**PLANNING AND ZONING COMMISSION REGULAR MEETING  
THURSDAY, SEPTEMBER 10, 2026 - 6:00 PM  
COUNCIL CHAMBERS, CITY HALL  
910 S. FRIENDSWOOD DR., FRIENDSWOOD, TX 77546**

**E. PRELIMINARY PLAT: GCCDD BAKER ROAD FACILITY**

**F. PRELIMINARY PLAT: HIGHPOINT CHURCH OF TEXAS, INC.**

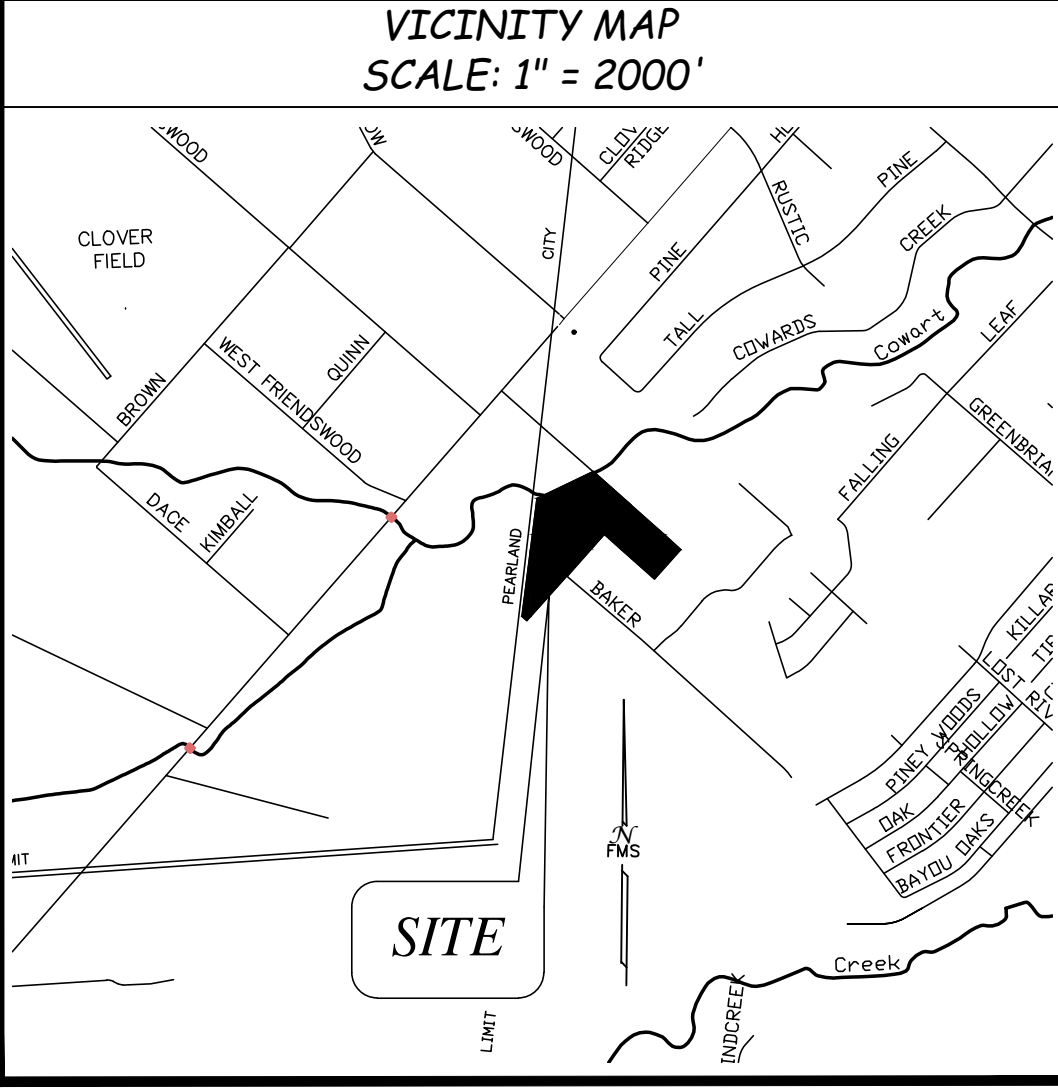
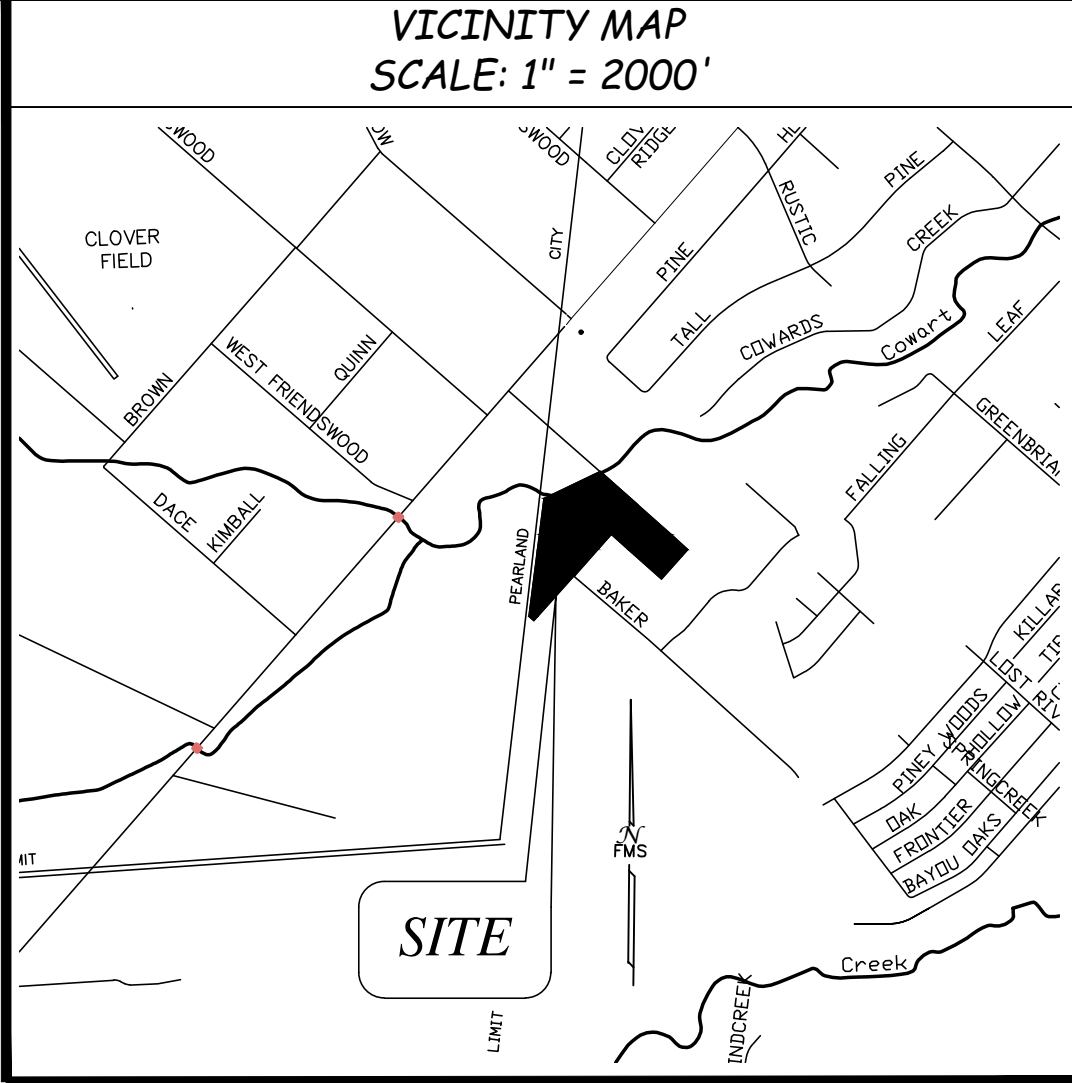
| <b>Comment ID</b> | <b>Page Reference</b> | <b>Reviewer : Department</b> | <b>Review Comments</b>                                                                                                                                                                                                                                                              | <b>Applicant Response Comments</b> |
|-------------------|-----------------------|------------------------------|-------------------------------------------------------------------------------------------------------------------------------------------------------------------------------------------------------------------------------------------------------------------------------------|------------------------------------|
| 28                | PLAT1                 | Jil Arias : Engineering      | IV.B.2.b(15) Show existing & proposed utilities on & up to 200' adjacent to tract.                                                                                                                                                                                                  |                                    |
| 29                | PLAT1                 | Jil Arias : Engineering      | IV.B.2.b(18) Show Special Flood Hazard Area boundaries                                                                                                                                                                                                                              |                                    |
| 17                | PLAT1                 | Becky Bennett : Planning     | Use current version of standard plat notes. <a href="#">Link</a>                                                                                                                                                                                                                    |                                    |
| 20                | PLAT1                 | Becky Bennett : Planning     | VIII.C.2. Locate wells API 167-00023 and 167-00024. Label as plugged.                                                                                                                                                                                                               |                                    |

| Comment ID | Page Reference | Reviewer : Department    | Review Comments                                                                                                                                                                                                                                              | Applicant Response Comments |
|------------|----------------|--------------------------|--------------------------------------------------------------------------------------------------------------------------------------------------------------------------------------------------------------------------------------------------------------|-----------------------------|
| 42         | PLAT1          | Becky Bennett : Planning | Confirm acreage and metes and bounds description after moving lot line to center of creek.                                                                                                                                                                   |                             |
| 45         | PLAT1          | Aubrey Harbin : Planning | This 20-ft roadway needs to remain...dedicate an additional 20 feet adjacent to make 40 feet. in the future, the other property owner will be expected to dedicate the remaining 20 fee to achieve the 60ft ROW. (arrows different than original submission) |                             |
| 46         | PLAT1          | Aubrey Harbin : Planning | This should only be 30 feet. (can be addressed on the final plat)                                                                                                                                                                                            |                             |
| 48         | PLAT1          | Aubrey Harbin : Planning | This 40 feet ended at the county line.                                                                                                                                                                                                                       |                             |
| 49         | PLAT1          | Aubrey Harbin : Planning | 20-foot Reservation for Road and Street Purposes Vol. 267, Page 410 GCDR (can be addressed on final plat)                                                                                                                                                    |                             |
| 50         | PLAT1          | Aubrey Harbin : Planning | What is this line? 10-ft HLP Easement continued? Existing power lines are outside the backyard fences. (can be addressed on final plat)                                                                                                                      |                             |
| 51         | PLAT1          | Aubrey Harbin : Planning | 10-ft WLE (can be addressed on final plat)                                                                                                                                                                                                                   |                             |
| 52         | PLAT1          | Aubrey Harbin : Planning | O.P.R.G.C.Tx. (address on final plat)                                                                                                                                                                                                                        |                             |

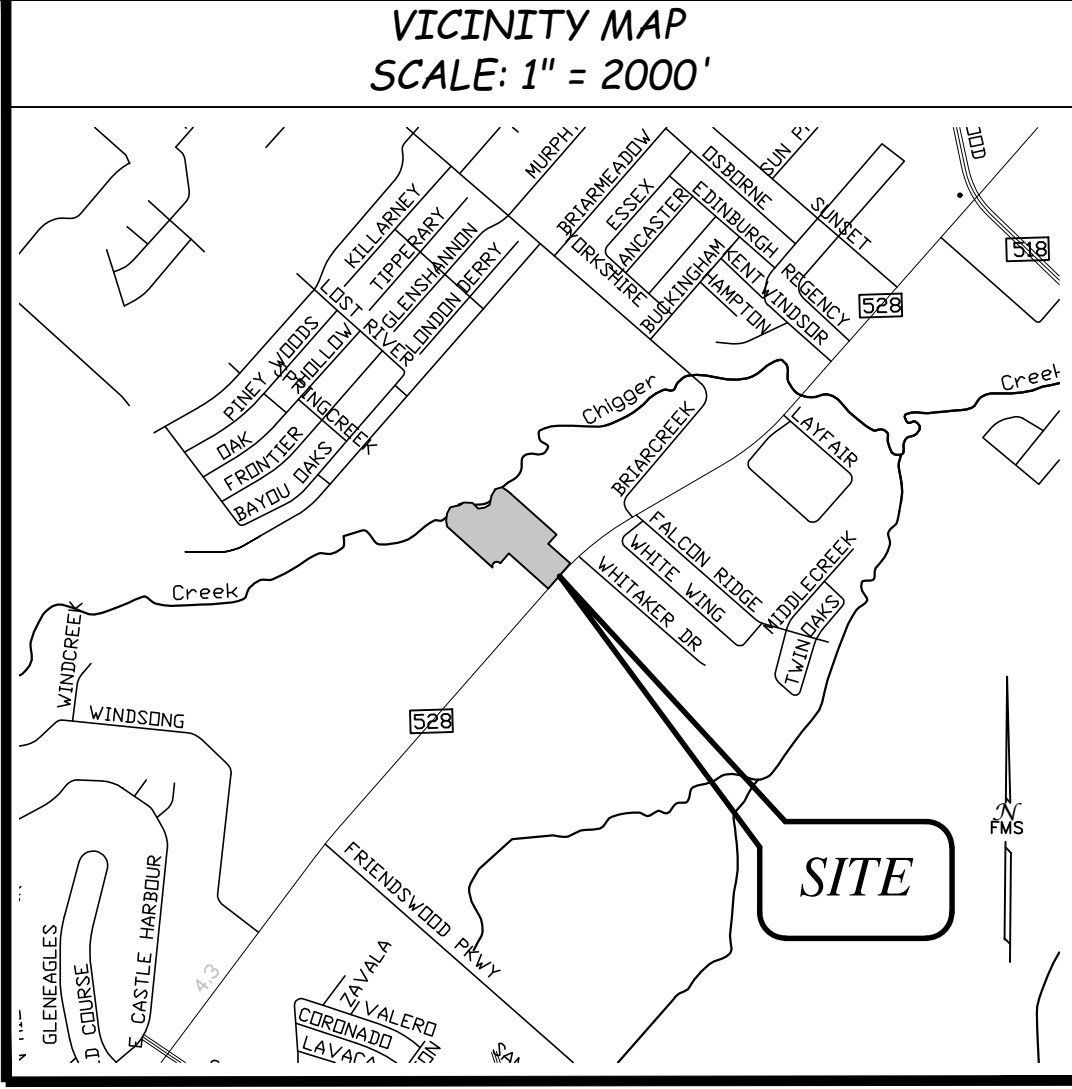
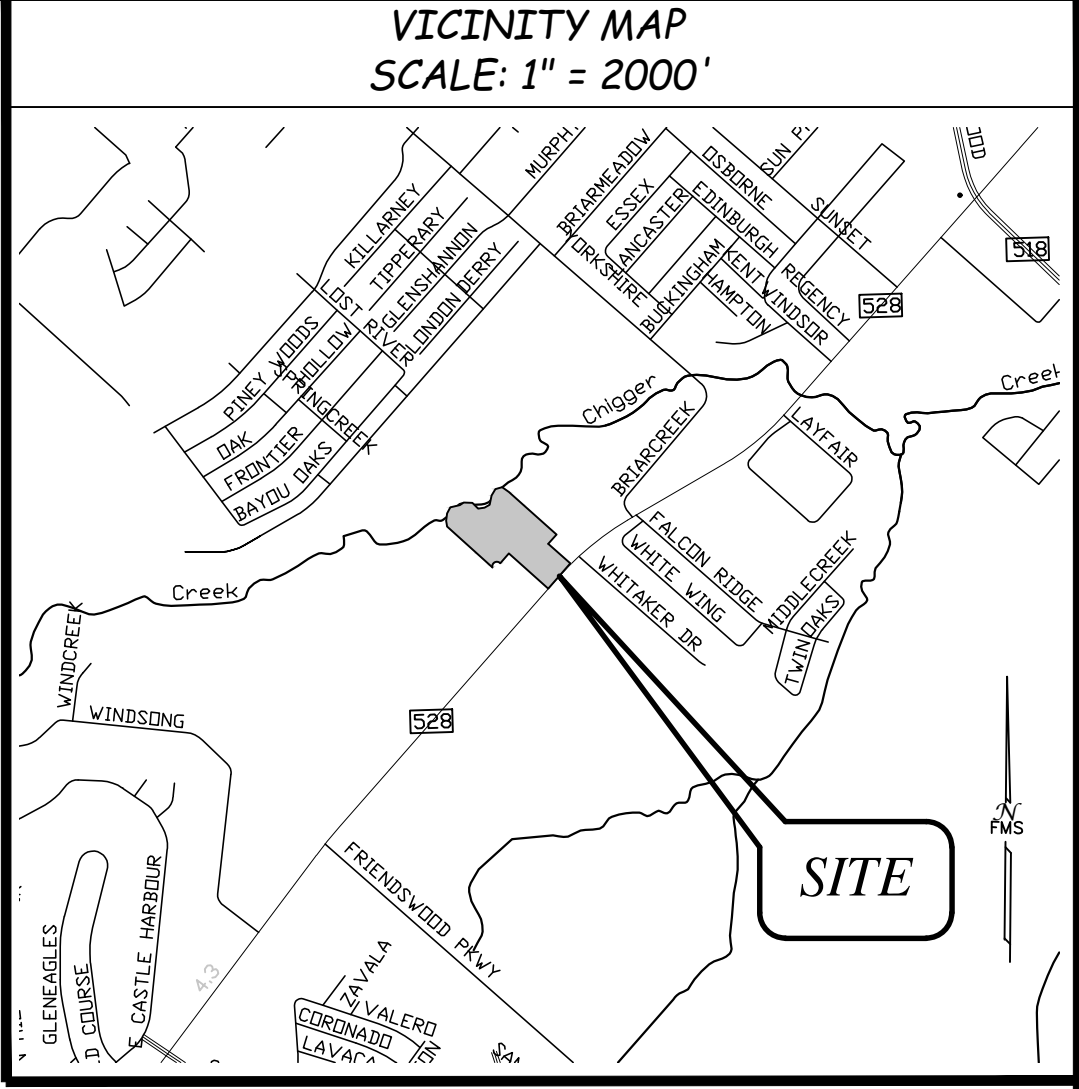
| <b>Comment ID</b> | <b>Page Reference</b> | <b>Reviewer : Department</b> | <b>Review Comments</b>                                                                                                                                                          | <b>Applicant Response Comments</b> |
|-------------------|-----------------------|------------------------------|---------------------------------------------------------------------------------------------------------------------------------------------------------------------------------|------------------------------------|
| 26                | Plat1                 | Jil Arias : Engineering      | Provide a 10' sanitary sewer parallel to FM 528 for City's planned future sanitary sewer project.                                                                               |                                    |
| 15                | Plat1                 | Becky Bennett : Planning     | IV.B.3.c.(5) Draw pipeline location and 50-foot build line from pipeline (can defer to final plat)                                                                              |                                    |
| 32                | Plat2                 | Becky Bennett : Planning     | Remove reference to 'minor plat' in the commission acknowledgment.                                                                                                              |                                    |
| 33                | Plat2                 | Becky Bennett : Planning     | IV.B.2.b.(7) and (8). Update title block on Sheet 1 to reflect 1 Block, 1 Lot, 0 Reserves.                                                                                      |                                    |
| 34                | Plat2                 | Becky Bennett : Planning     | IV.B.2.b.(1)(d) Revise HighPoint to one word in the owner's info throughout.                                                                                                    |                                    |
| 35                | Plat2                 | Becky Bennett : Planning     | Lien holder is Gene S. Hagood                                                                                                                                                   |                                    |

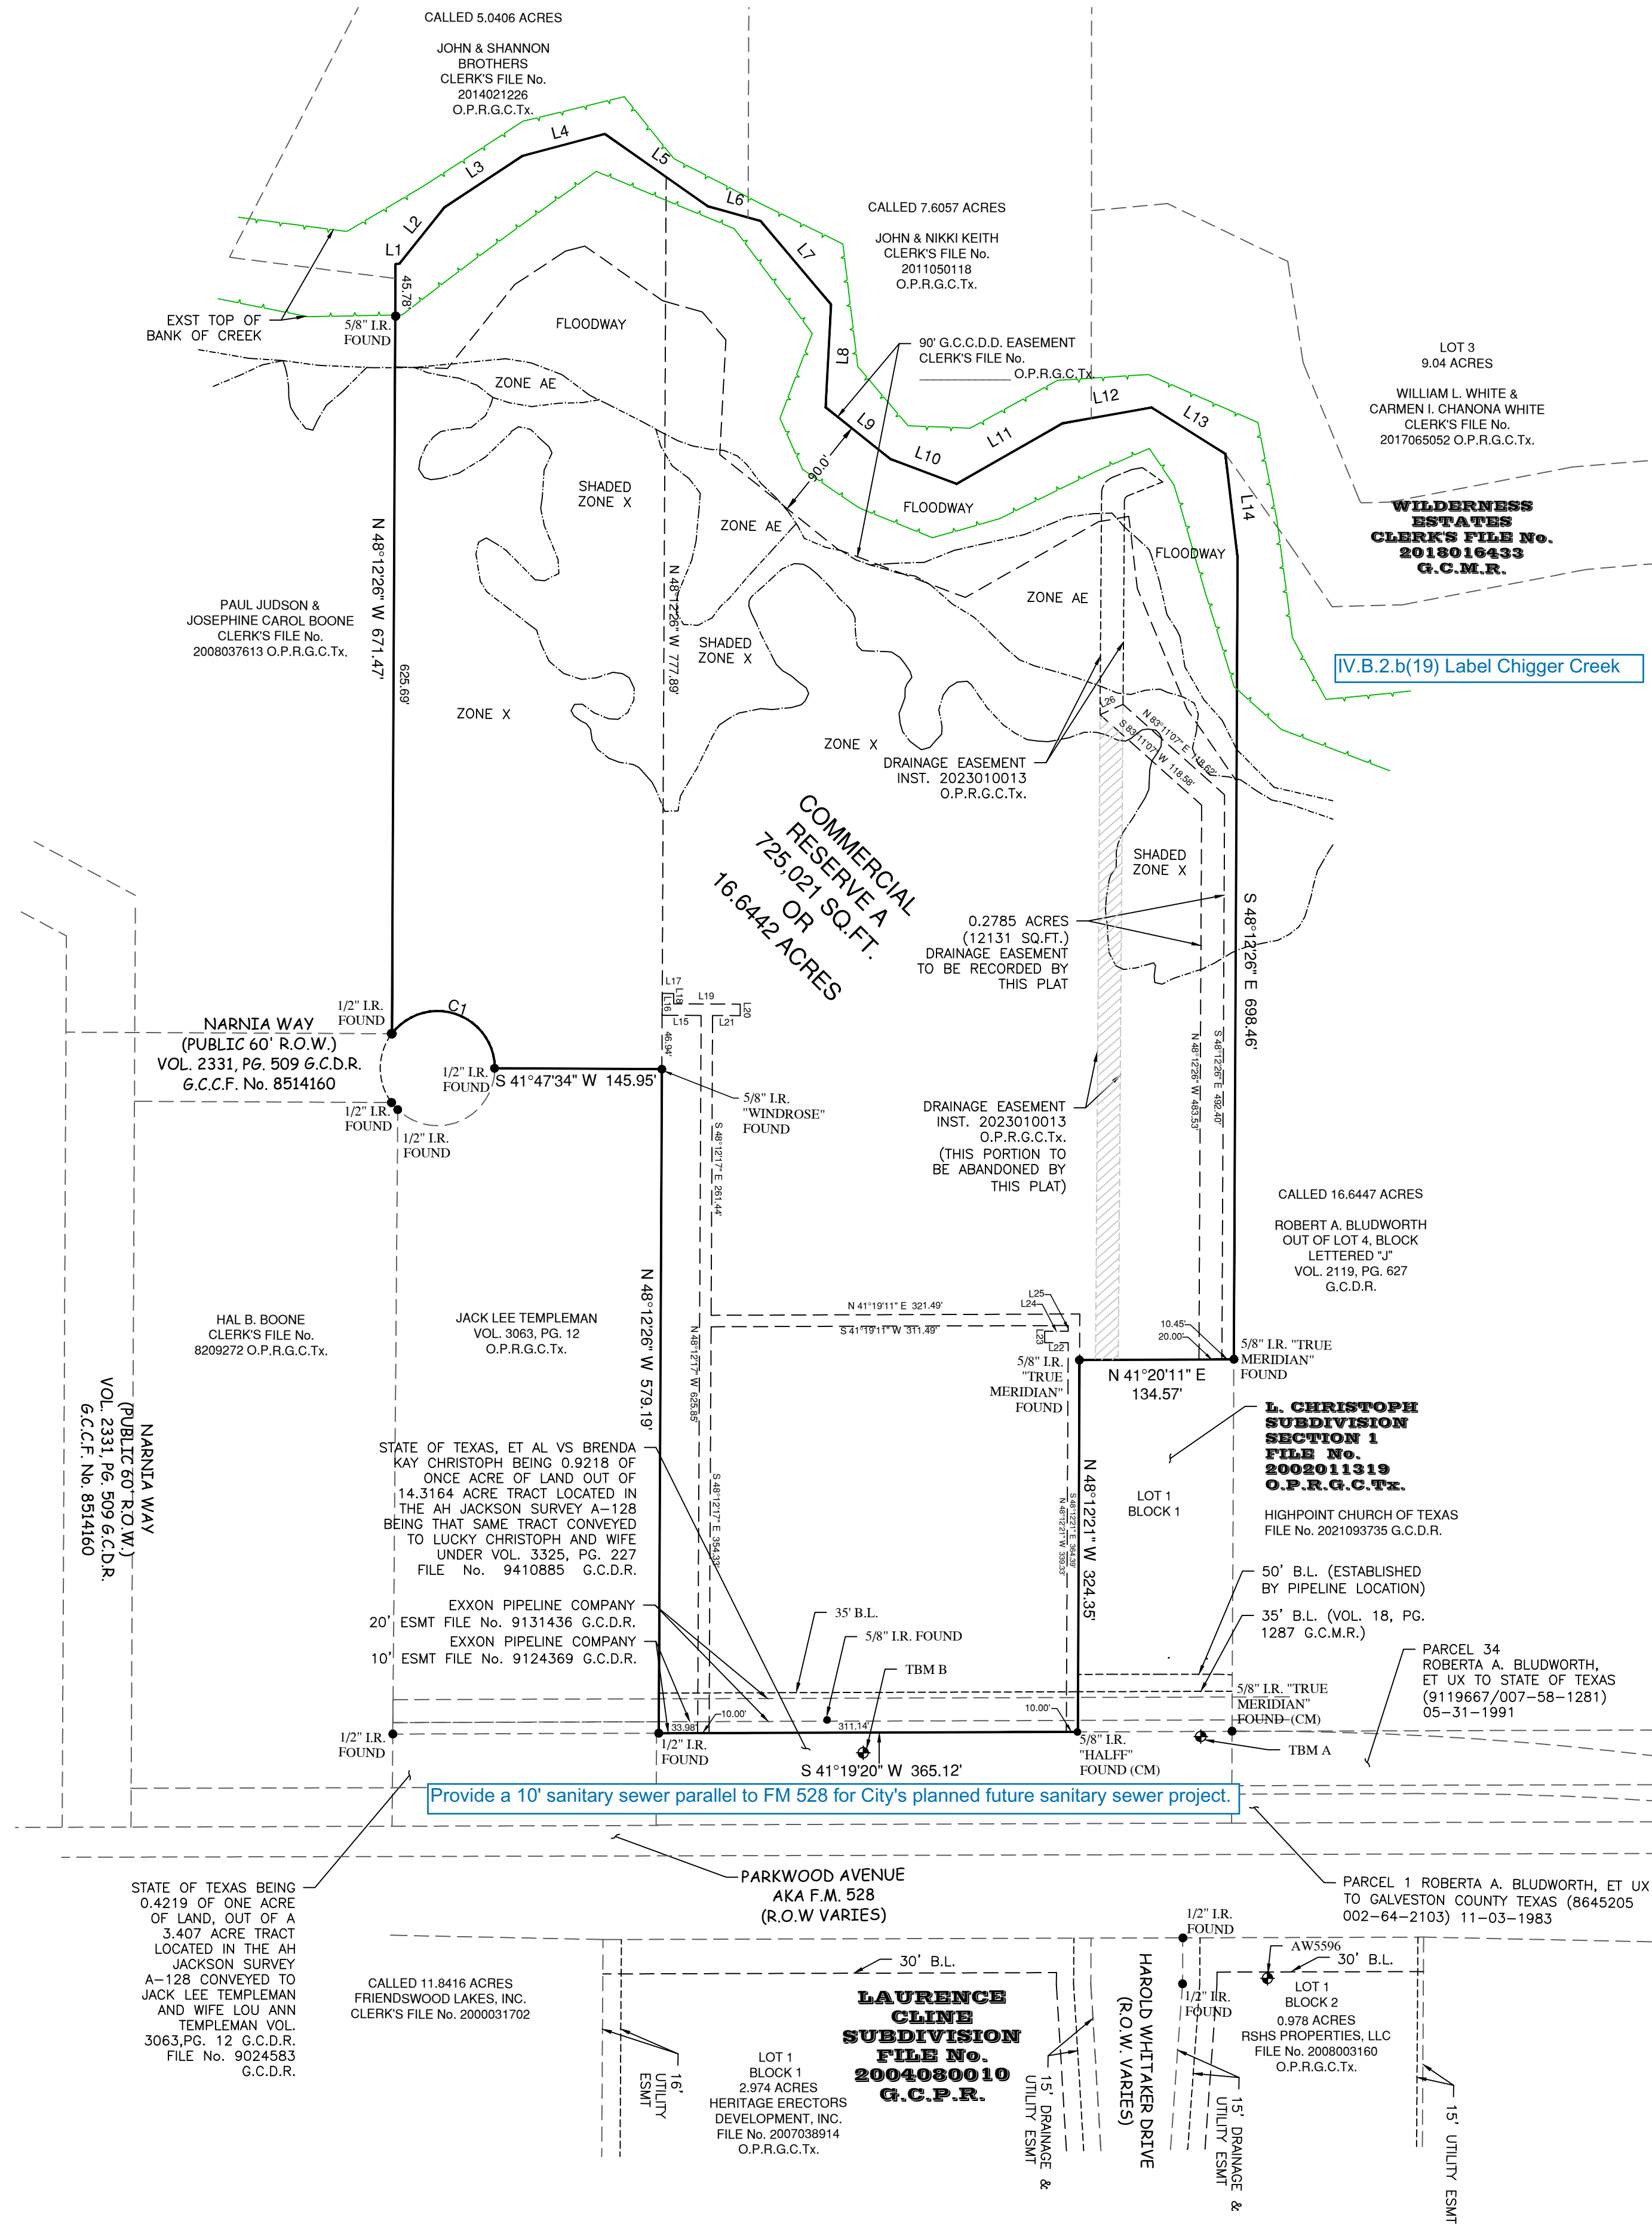
IV.B.2.b(19) Label Chigger Creek
